RE: File No. 11239 – Rindge Commons Pre-K Interior Fit-Out - Addendum No. 2

Addendum No. 2

Rindge Commons Pre-K Interior Fit-Out

ADDENDUM # 2

SYMBOL LIST/ FIXTURE SCHEDULE

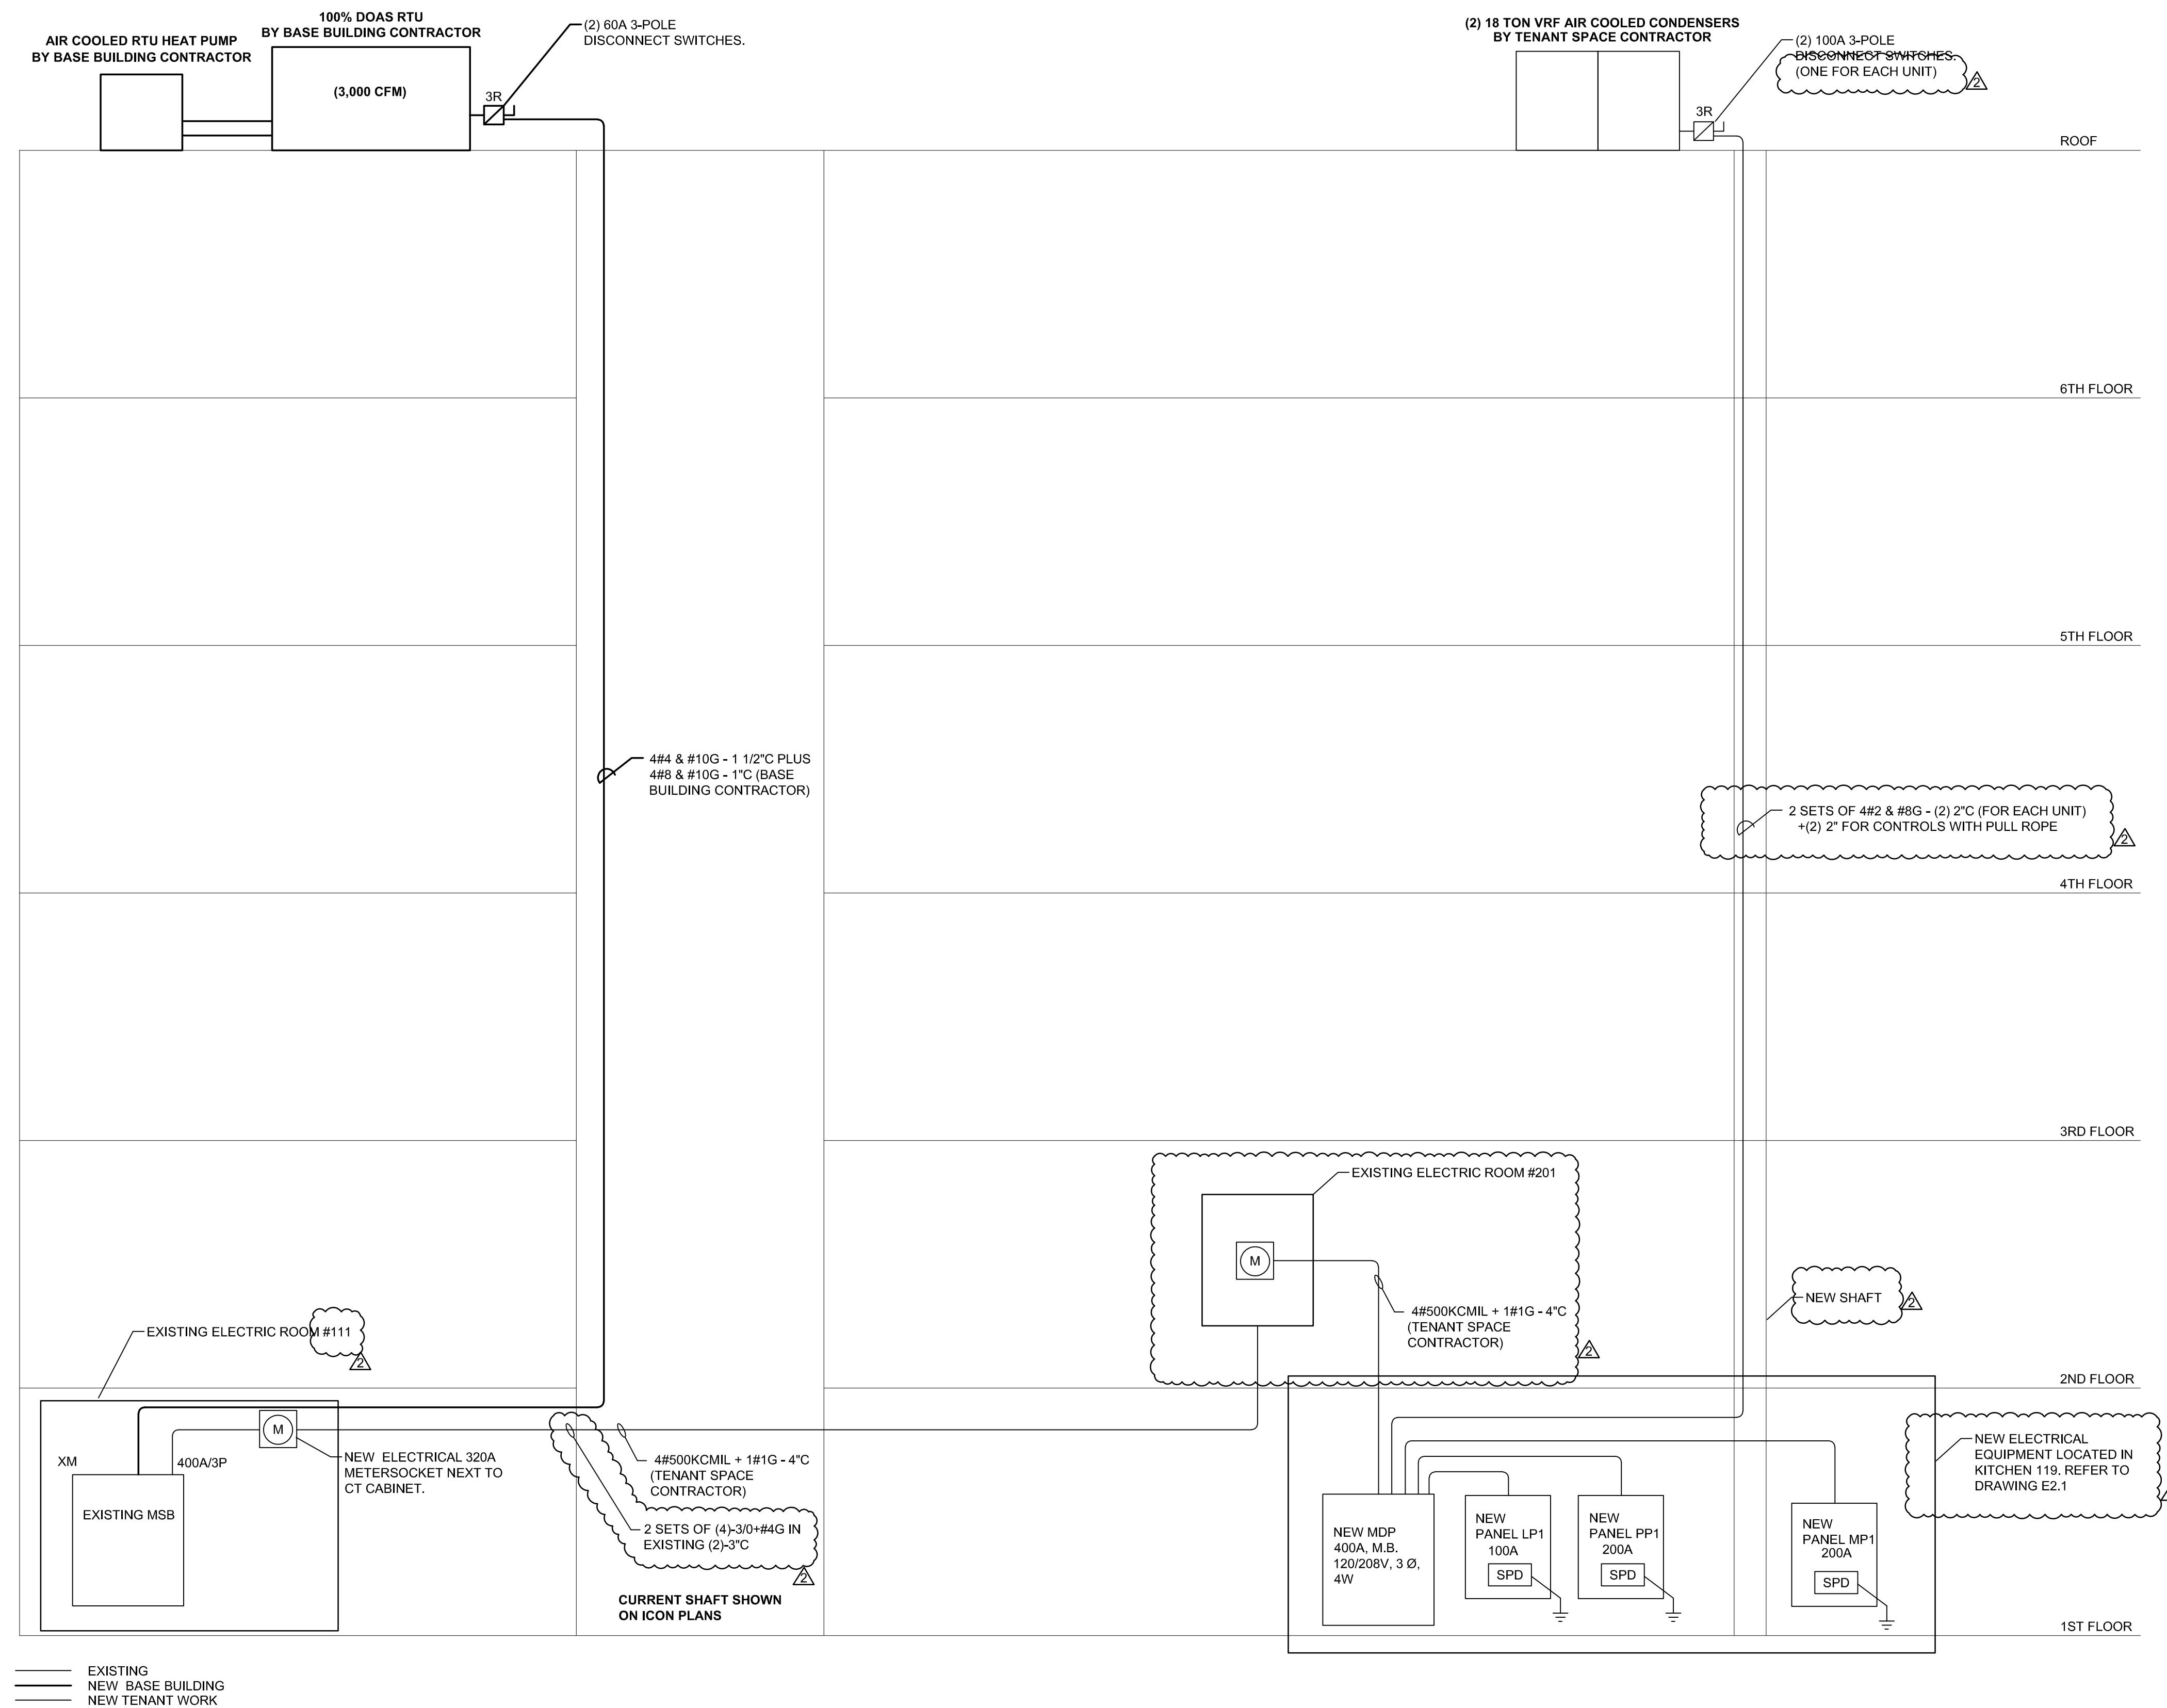
Response: Communication demarc is located in Electric Room 111.
- **ITEM 2.10** Question: Drawing E0.1, Lighting fixture schedule, does not indicate Types LR24, LR4

Response: Refer to revised drawing E0.1.
- **ITEM 2.11** Question: Drawing E0.1, Lighting fixture schedule, lighting drawings do not indicate any Type LS6 lights. Please confirm this is correct

Response: Refer to revised drawing E0.1
- **ITEM 2.12** Question: Please provide a lighting control specification
Response: Refer to Drawing E0.4 of Addendum #1 for lighting control requirements.

Sheet Title
ONE LINE RISER

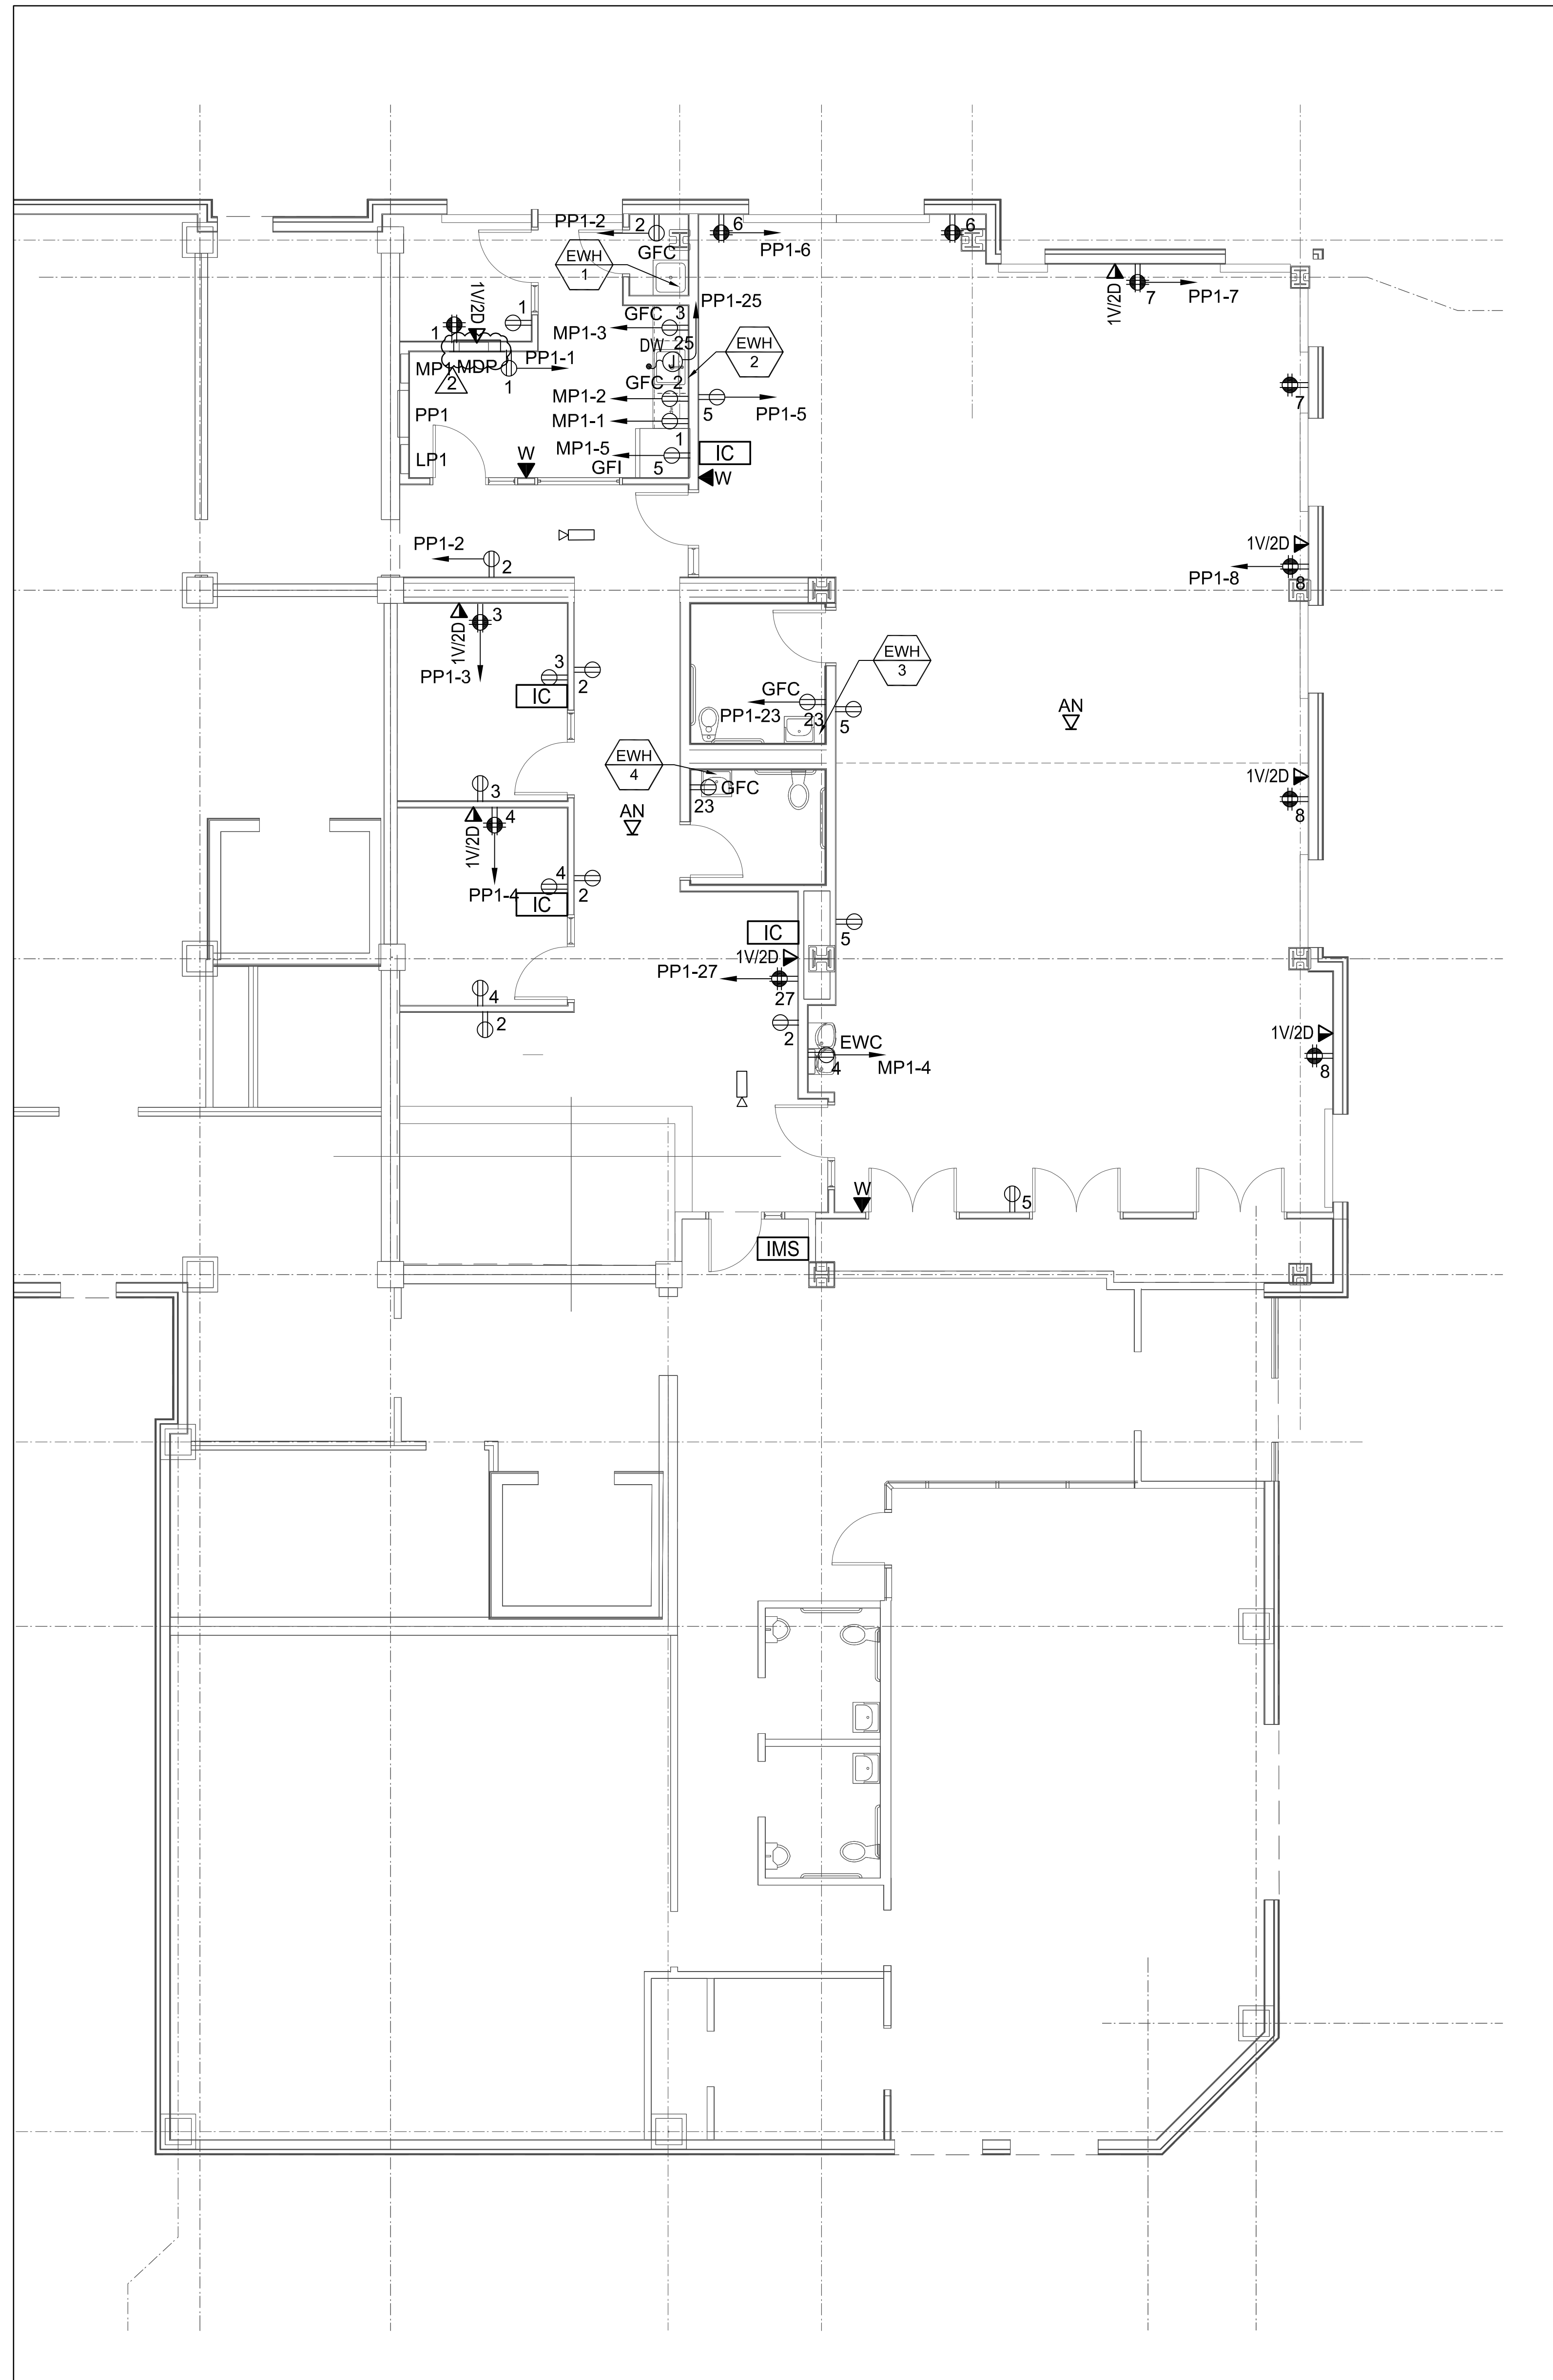
- **ITEM 2.3** Question: Drawing E0.3 - Electrical Riser: Please provide the location of the existing MSB indicated on the floor plan. Please confirm the existing MSB has an available 400 amp breaker.

Response: Switchboard "MSB" is located in Electric Room 111. The 400A breaker is provided in the "MSB" and the meter socket is existing located in Electric Room E201 on the second floor. Refer to Drawing E0.3
